**Re: Request for a Modification of Plans Approved by the Zoning Commission
Pursuant to Zoning Commission Order No. 17-10
Consolidated PUD & Map Amendment @ Square 5196, Lots 19, 37, 805, and
814**

REQUEST FOR MODIFICATION OF PLANS APPROVED BY THE ZONING COMMISSION

**REQUEST FOR A MODIFICATION OF PLANS APPROVED BY THE
ZONING COMMISSION**

STRAND RESIDENCES
5119-5127 NANNIE HELEN BURROUGHS AVE., NE & 612 DIVISION
AVE., NE, WASHINGTON DC

SECOND FLOOR PLAN | ZM-10

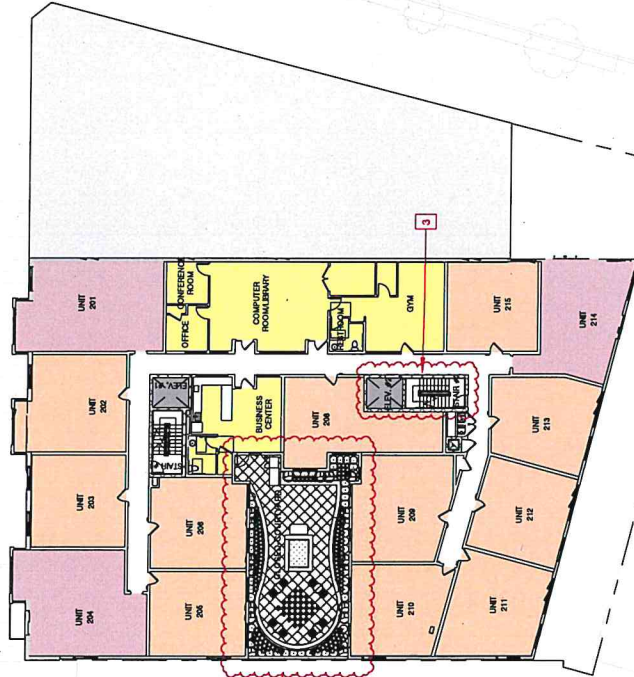
Item	BZA Sheet	Permit Sheet	Modification
1	A-09	A101	Bike spaces @ sidewalk of Nannie Helen Burroughs Rd increased from 7 spaces to 8 spaces, 6 for short-term residential use, 1 for short-term retail use & 1 for short-term community space use
2	A-09	A101	Due to structural configuration of the Bike Storage Room, the bike spaces decreased from 38 to 36 spaces, 34 are for long-term residential use, 1 is for long-term retail use & 1 is for long-term community space use
3	A-09, A-10,A-11,A-12	A101-A107	Location of stair #2 & elevator #2 flipped in position, placing the 10' high stair pop-up 33'-0" from the south roof edge and the 4' high elevator overrun 10'-8" from the courtyard roof edge, both remain more than the required 1:1 setback
4	A-09	A101	Exterior door of utility room changed in size from a single to a double door per Pepco's requirement.
5	A-09, A-16	A101, A202	Exterior door added next to garage door.

THIRD TO SIXTH FLOOR PLAN ZM-11

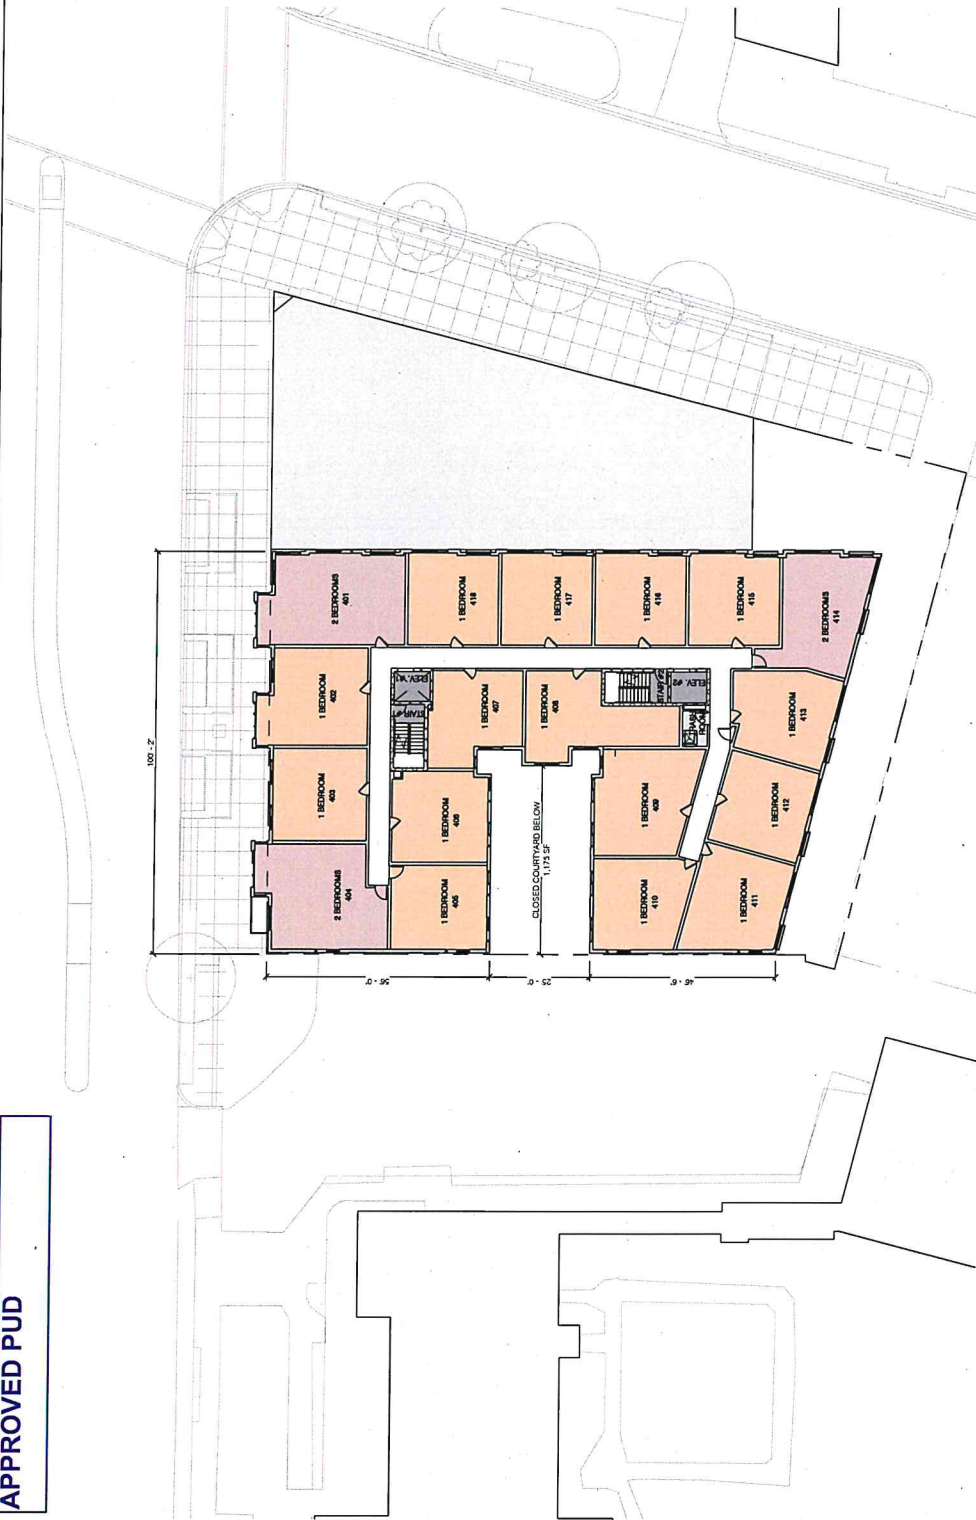
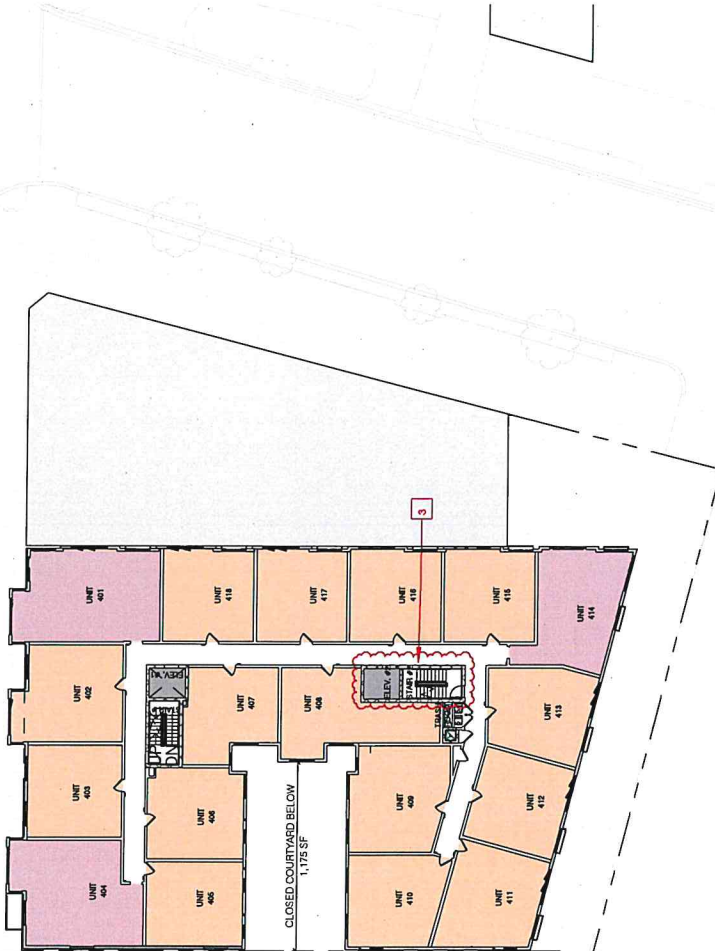
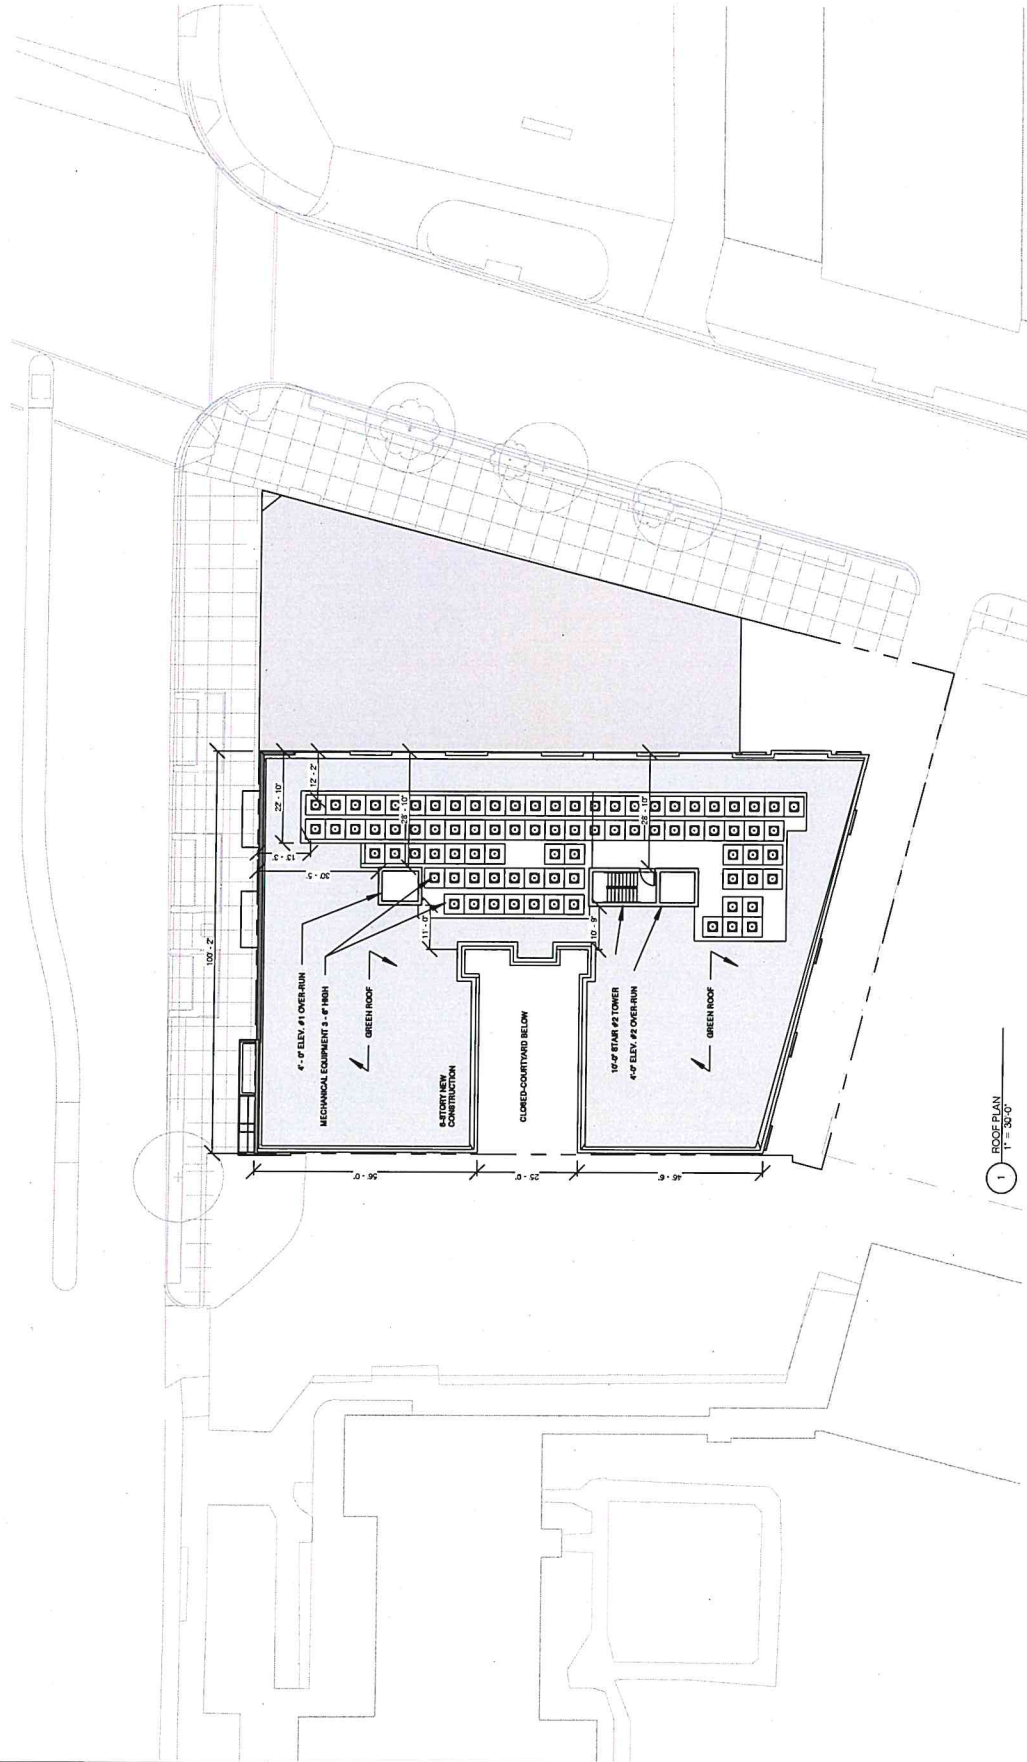
6	A-09	A101	Dimensions of planter on south-east of site reduced approximately 3' to align with adjacent parking.
7	A-10	A102	Landscaping of closed court revised, interior dimensions did not change
8	A-12	A107	6' high Generator on concrete pad added to roof setback 30'-8" from the north roof edge, more than the required 1:1 setback.
9	A-12,A-15,A-16, A-17,A-18	A107, A200-A203	6'-0" mechanical screen added around new generator, the setback from the north roof edge is 22'-5", more than the required 1:1 setback
10	A-15,A-16,A-17,A-18	A200-A203	The mullion placement of all window types on 2 nd -6 th floor revised, the rough openings of the windows did not change in size.
11	A-15,A-16,A-17	A200-A202	Balconies changed from horizontal slats to vertical pickets.
12	A-15	A200	Brick cornice profile revised.

ROOF PLAN ZM-12

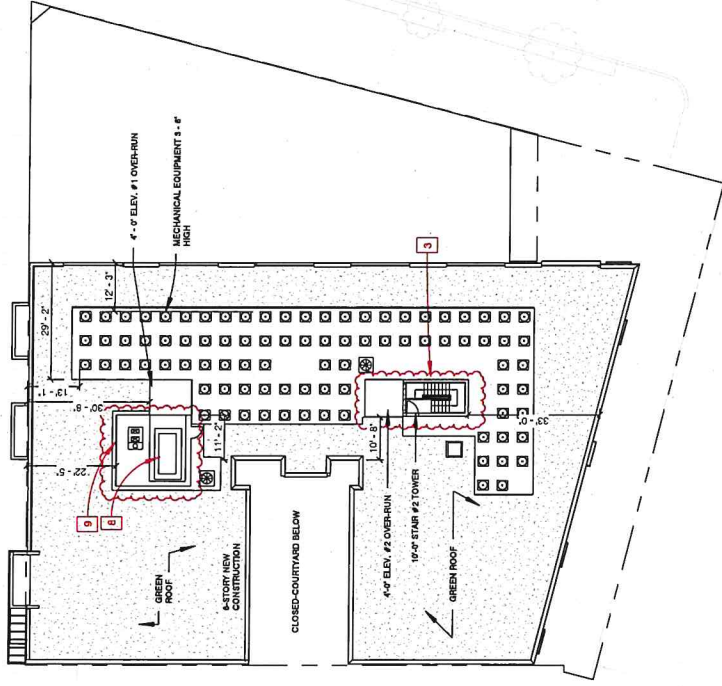
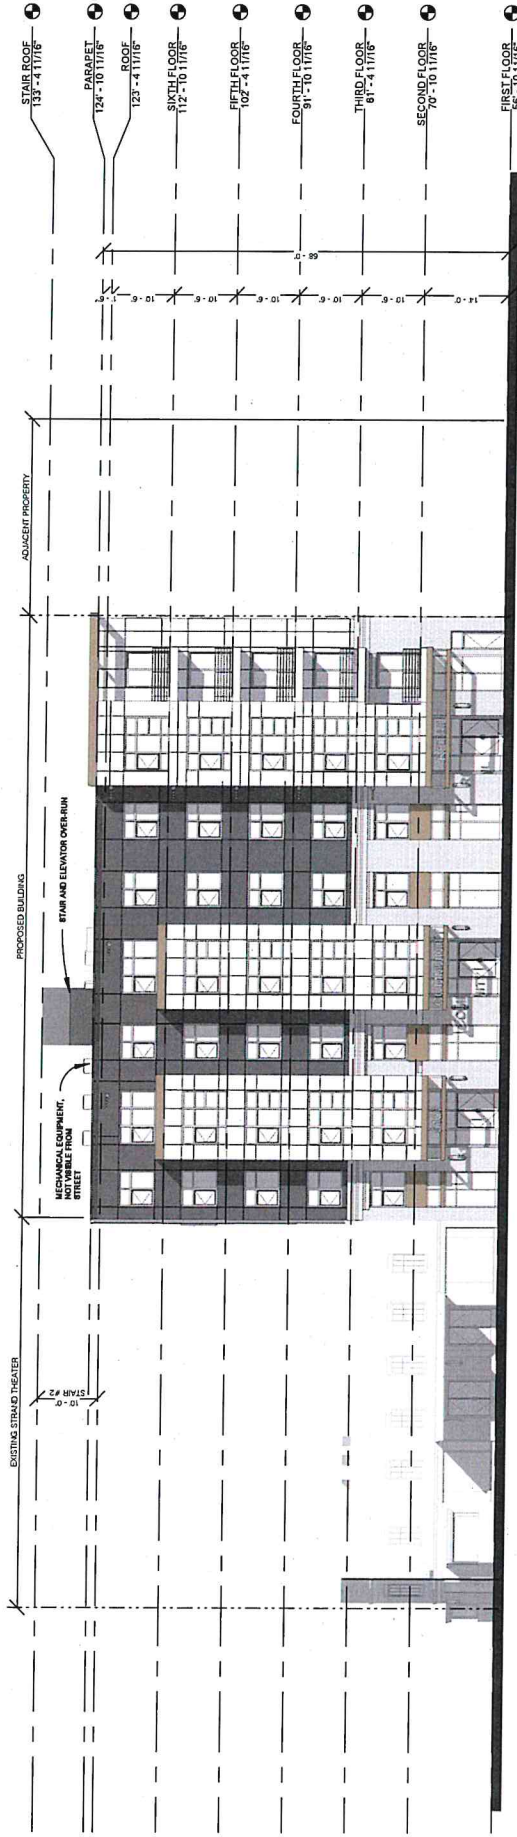
- **Item 7:** Landscaping of closed court revised, interior dimensions did not change
 - **Item 8:** 6' high Generator on concrete pad added to roof setback 30'-8" from the north roof edge, more than the required 1:1 setback.

- **Item 9:** 6' mechanical screen added around new generator, the setback from the north roof edge is 22'-5", more than the required 1:1 setback
 - **Item 10:** The mullion placement of all window types on 2nd-6th floor revised, the rough openings of the windows did not change in size.

NORTH ELEVATION A-15

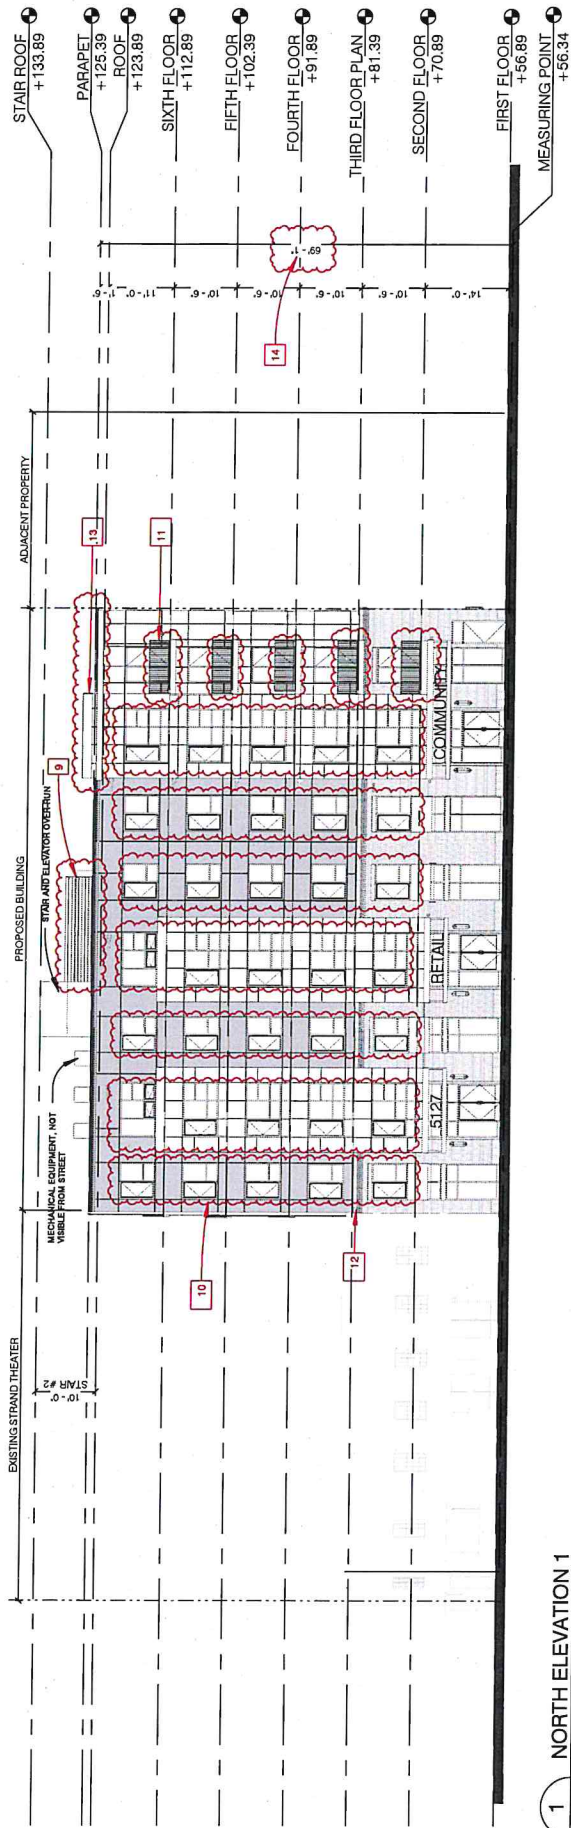
- **Item 11:** Balconies changed from horizontal slats to vertical pickets.
 - **Item 12:** Brick cornice profile revised.
 - **Item 13:** Tower cornice/canopy design revised, material has not changed.

13	A-15	A200	Tower cornice/canopy design revised, material has not changed.
14	A-15,A-16,A-17,A-18	A200-A203	Building height changed from 68'-0" to 69'-1" (a change of 1'-1"). The roof structure increased in size, thus causing an increase in the height from the 6 th floor to the roof.

SOUTH ELEVATION ZM-16

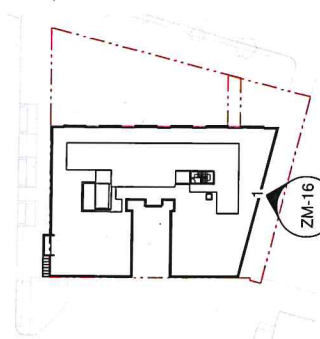
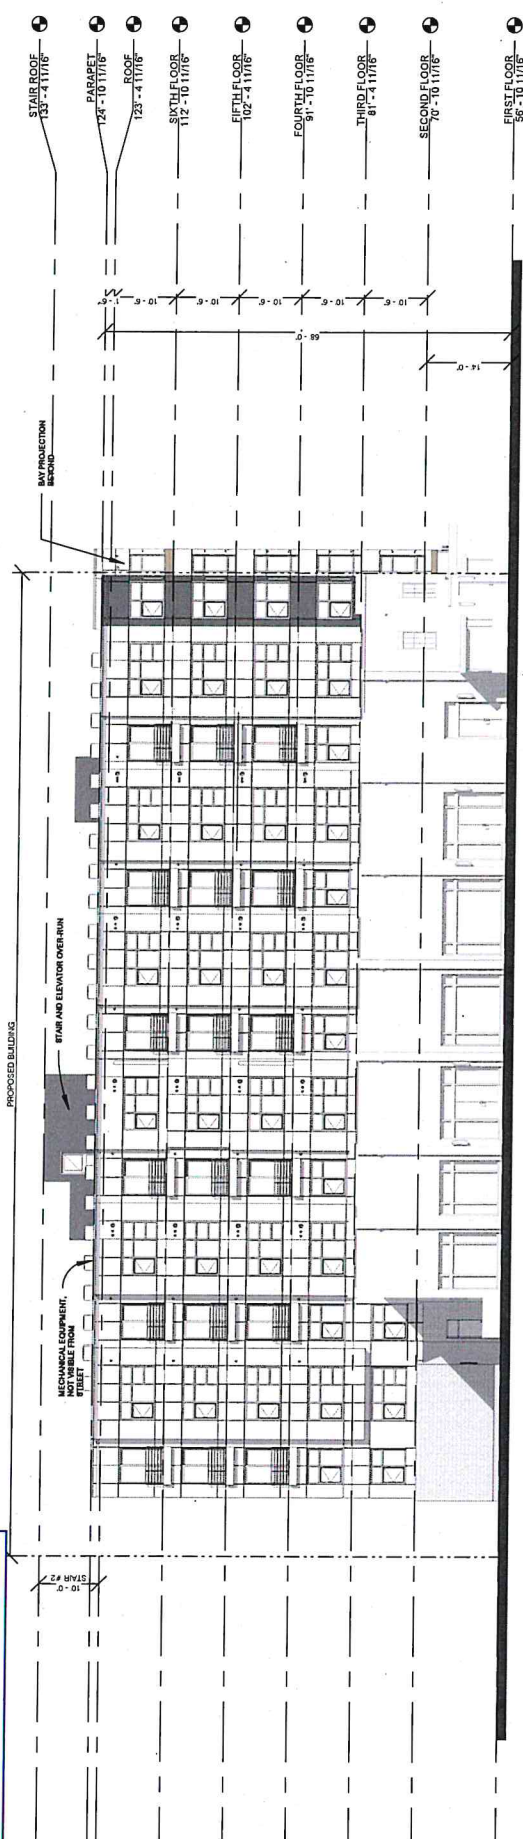
- **Item 4:** Exterior door of utility room changed in size from a single to a double door per Pepco's requirement.
 - **Item 5:** Exterior door added next to garage door.
